# intel® Technical Advisory

TA-667-1

## Intel® Server Chassis SPSH4 and SRS4 SAF-TE Controller Crystal Operating Outside Design Specifications

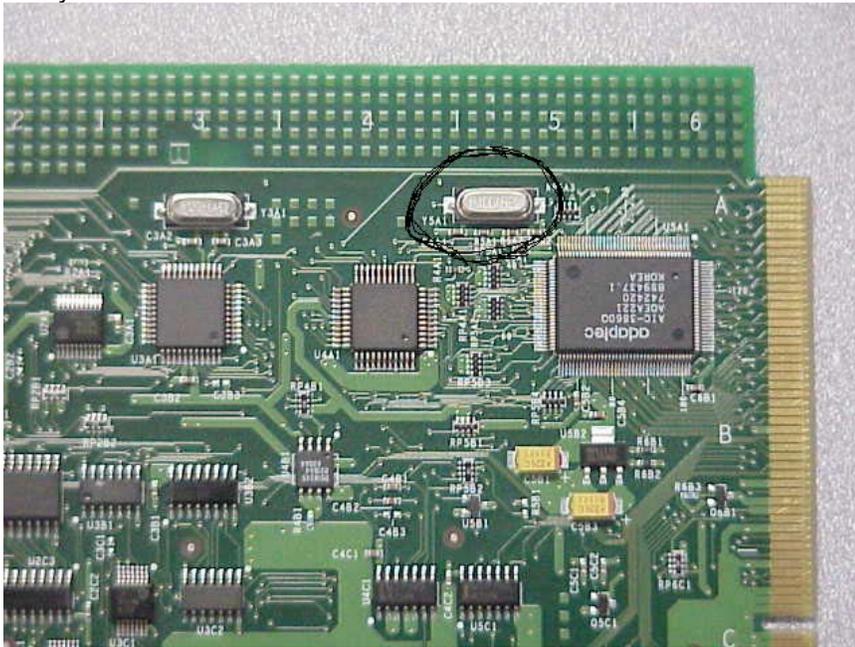
Customers with Intel Server Chassis SPSH4 and SRSH4 chassis products, spares, and accessory kits with serial number indicating product was built between WW27-36 (both inclusive) are suggested they visually examine the SAF-TE card to determine if it is affected by the "crystal" issue. To screen the SAF-TE card please follow the steps outlined below:

1. Remove hot swap drive bay from the Intel Server Chassis SPSH4 and SRSH4 chassis (for chassis products).
2. Remove the white plastic piece (part number 743492-004) attached to the hot swap backplane bay with four screws.
3. Remove the hot swap backplane board and the attached SAFTE card from the hot swap backplane bay.
4. Find the crystal (silver colored) at location Y5A1 on the SAFTE card (PBA A42862-110). The crystal location is shown in the photograph below.
5. Crystals marked with "R400 XXXX" are NOT affected by this issue. Crystals marked with "40.0 [N] XXXX" are affected by this issue. The XXXX markings are date-code related and should be considered as don't cares for the "crystal" issue
